Subject: Re: [Application No. A/NE-STK/32] – Comments from the Leisure and Cultural Services Department

Proposed Temporary Holiday Camp, Place of Recreation, Sports or
Culture (Hobby Farm), Field Study/Education/Visitor Centre, and
Public Vehicle Park (excluding Container Vehicle) for a period of 3 years
in “Village Type Development”, “Recreation (1)”, and the areas are
shown as ‘Road’ of various Lots in D.D 41 and the adjoining
Government Land, Sha Tau Kok, New Territories.

Further Comments from the New Territories North Tree Team LCSD:

Response to the Leisure and Cultural Services Department (LCSD)

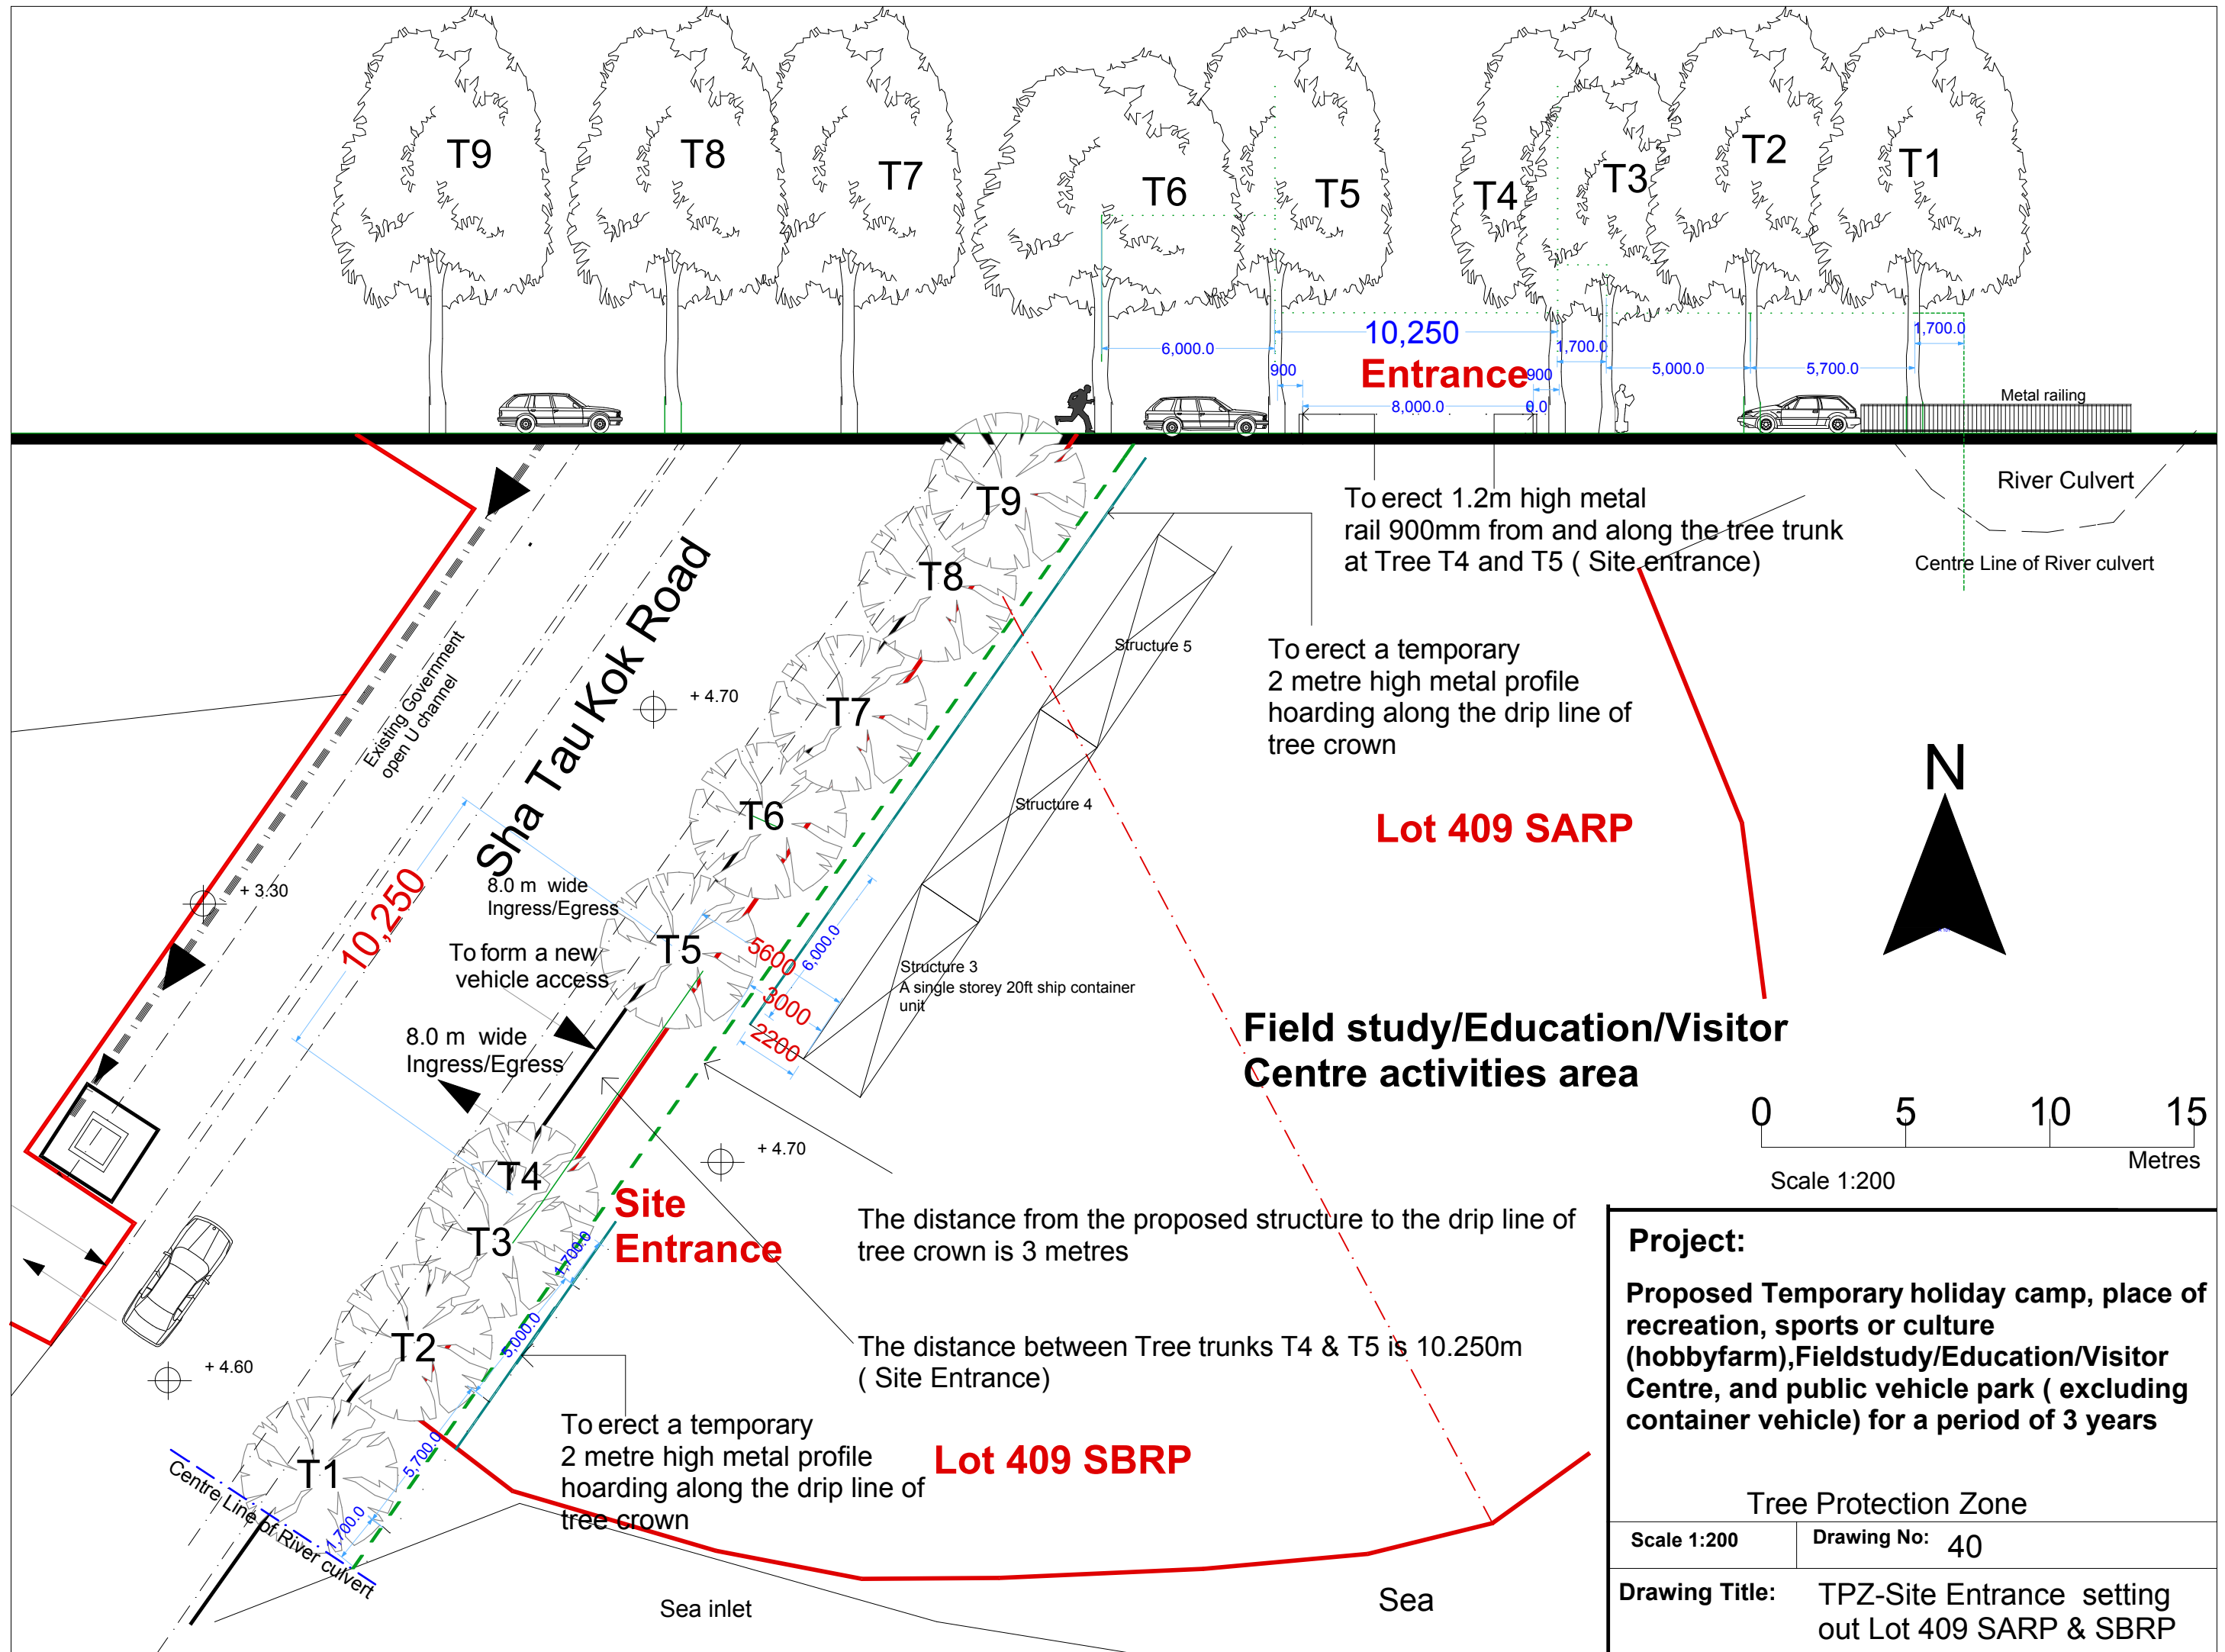
1. The applicant is requested to submit further information to indicate:
 - distance from the proposed Structure to the drip line of tree crown;
 - distance from the proposed structure to the tree trunk; and
 - distance from the run in / out to the tree trunks of T4 & T5.

2. According to the requirement of Transport Planning and Design Manual (TPDM) Volume 2, sufficient distance should be kept from the run in / out to the existing trees to avoid blocking of driving sight line (see **Photo** attached).
3. Meanwhile, the applicant should observe the "Guidelines on Tree Preservation during Development" of DEVB for the necessary requirement on tree protection (see **Attachment**).
[See attachment "Guidelines_on_Tree_Preservation_during_Development_e.pdf"]

I have reviewed our survey data for the Application Site and revised the Site Entrance Setting Out. The distance from the run in/run out to the tree trunks of T4 & T5, centre to centre of the tree trunks, is approximately 10,250 mm.

(Please refer to the Revised Site Entrance Setting Out drawing submitted herewith).

The average tree trunk size of those trees alongside the Application Site of Sha Tau Kok Road is 460mm in diameter, while the average drip line of the tree crown is approximately 5200 mm.

The width of the proposed site entrance is 8000 mm; there will be a gap of approximately 900 mm away from the tree on both sides.

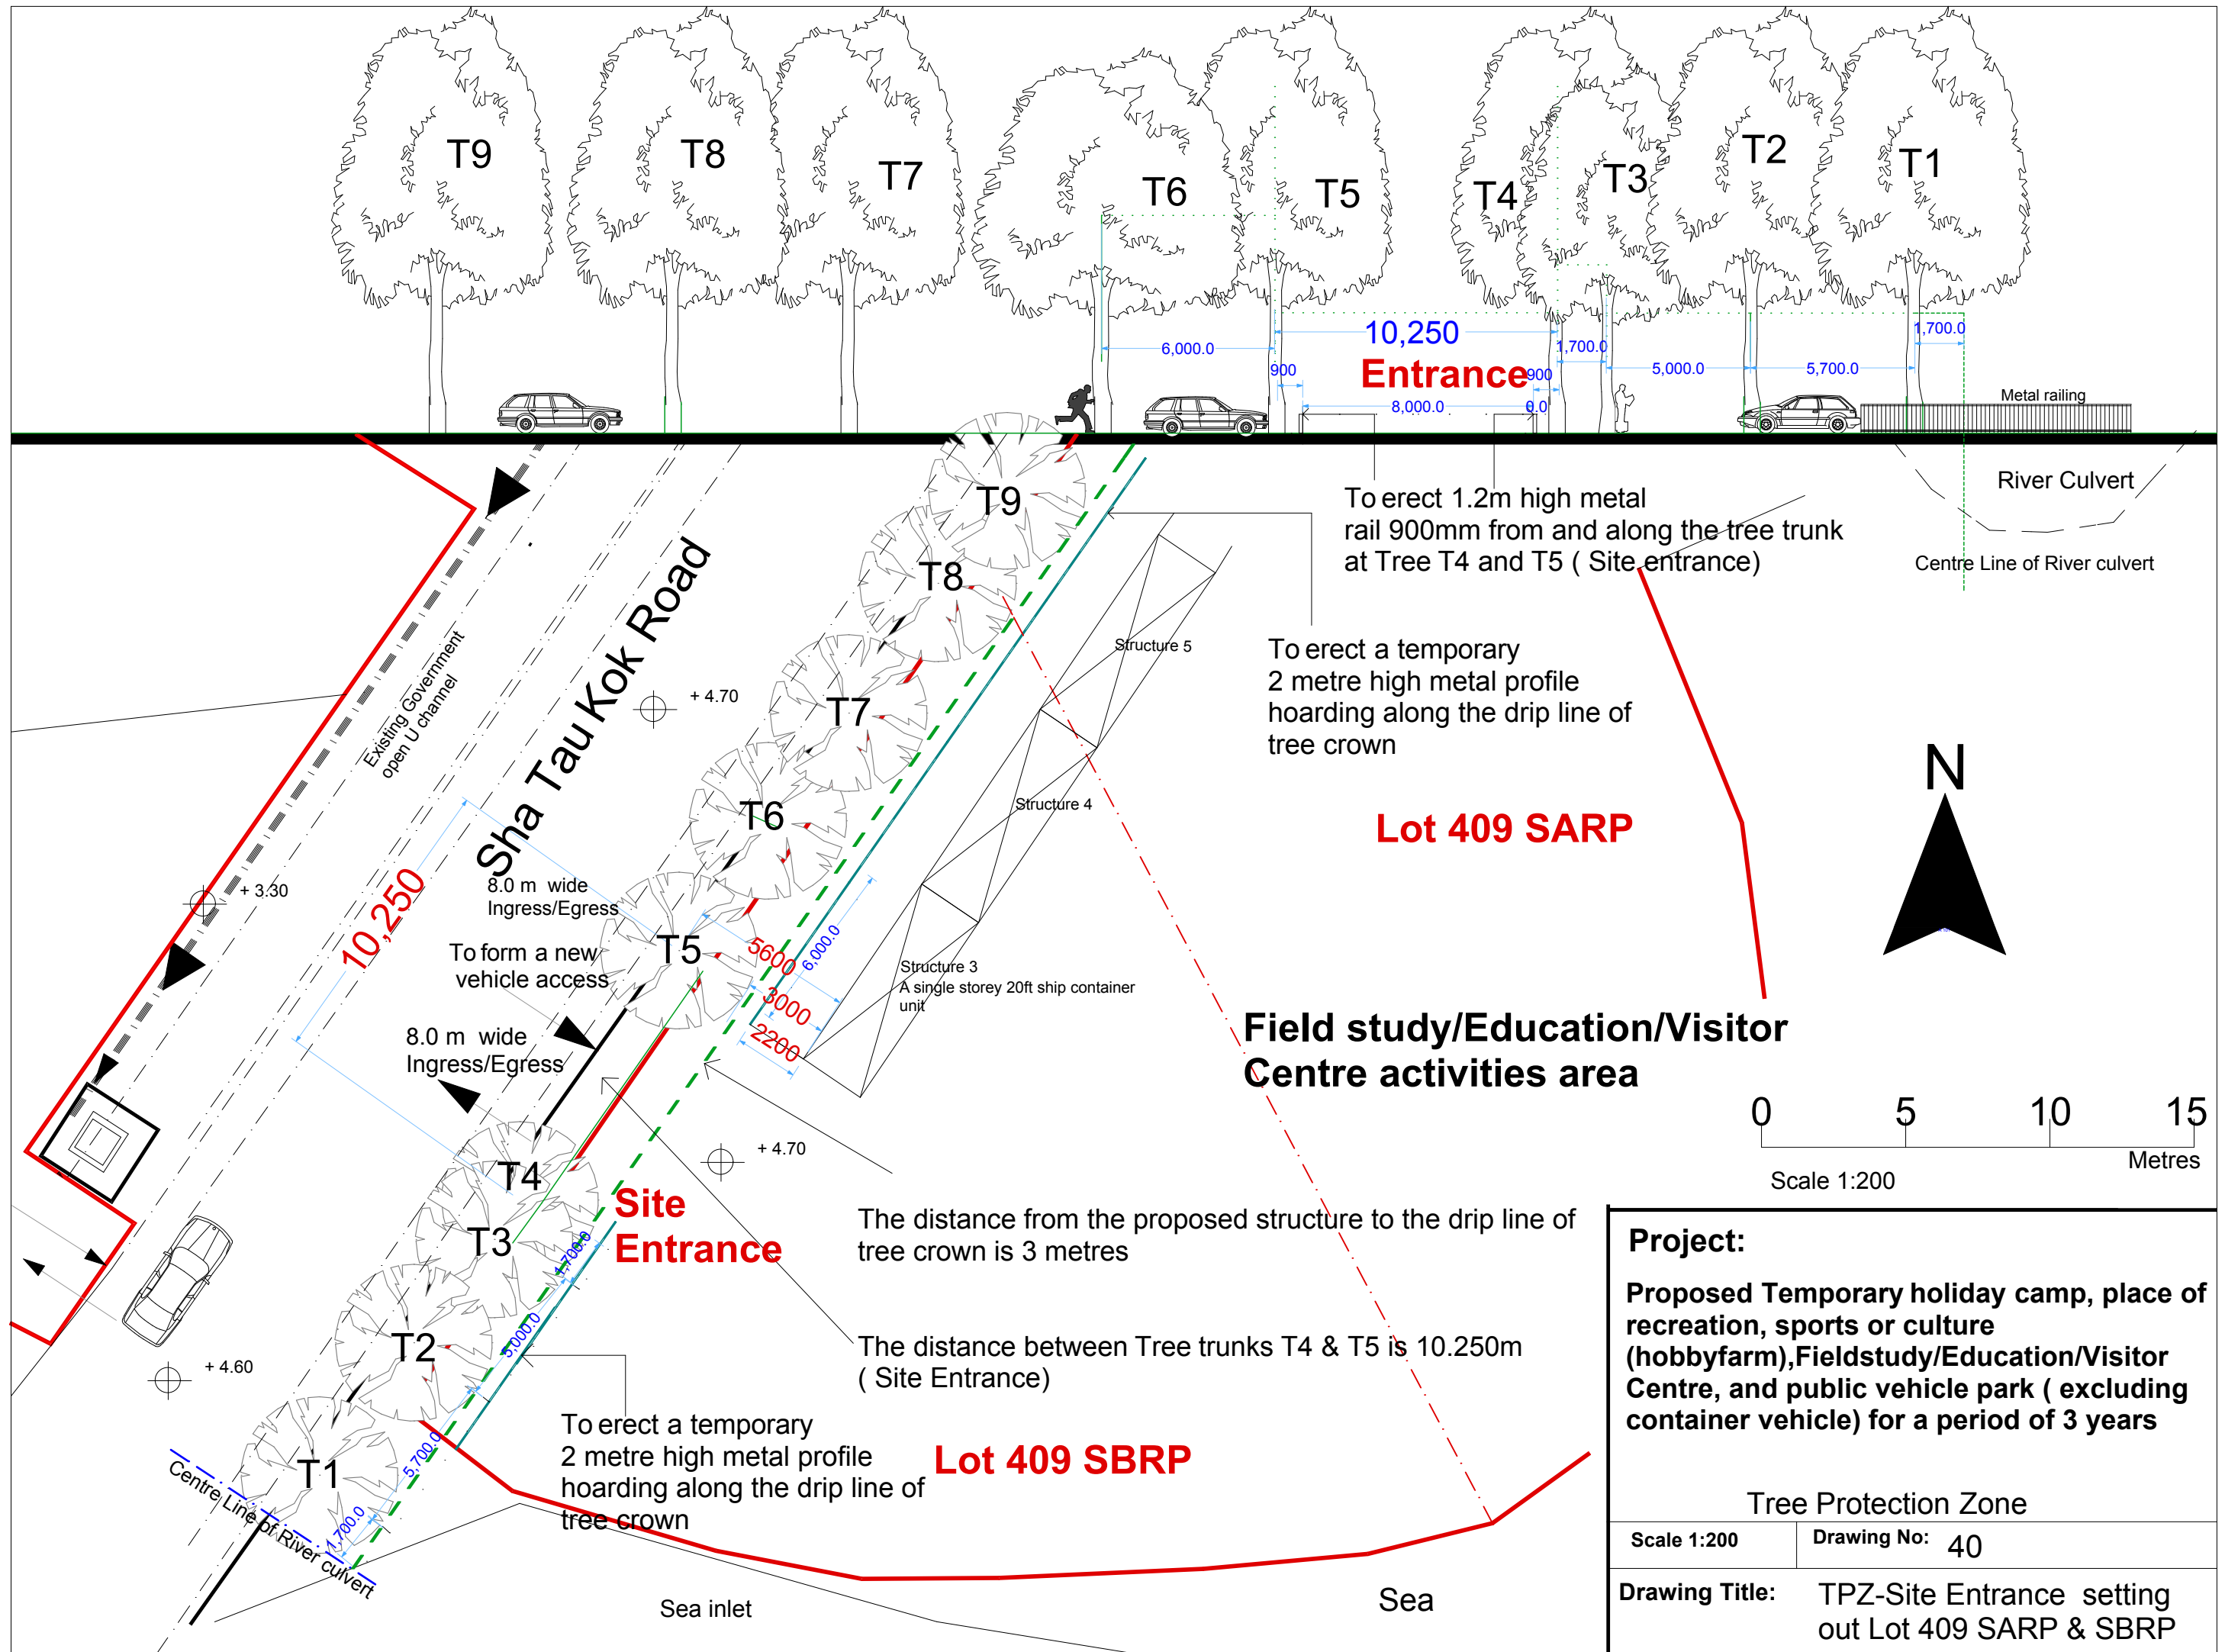
The applicant should revise the proposed vehicular access points to avoid affecting nearby trees. Should any tree under LCSD maintenance be inevitably affected by the captioned application, the applicant should act in accordance with the prevailing Technical Circular DEVB TC(W) No. 4/2020 - Tree Preservation (Available at: <https://www.greening.gov.hk/en/resource-centre/technical-circulars-practice-notes-and-guidelines/index.html>) and relevant guidelines stipulated by the Development Bureau and other departments.

To protect and preserve trees and the suburban area of the Application Site during the construction phase, a temporary, two meter high metal profile, hoarding along the drip line of the tree crown will be erected. In addition, a 1.2 meter high metal rail, will be erected on both sides of the site entrance. When the Application Site is in operation, the temporary hoarding will be upgraded to a more durable and sustainable uPVC Composite Fencing.
(Please refer to the Tree Protection Zone – Site Entrance Setting Out drawing submitted herewith).
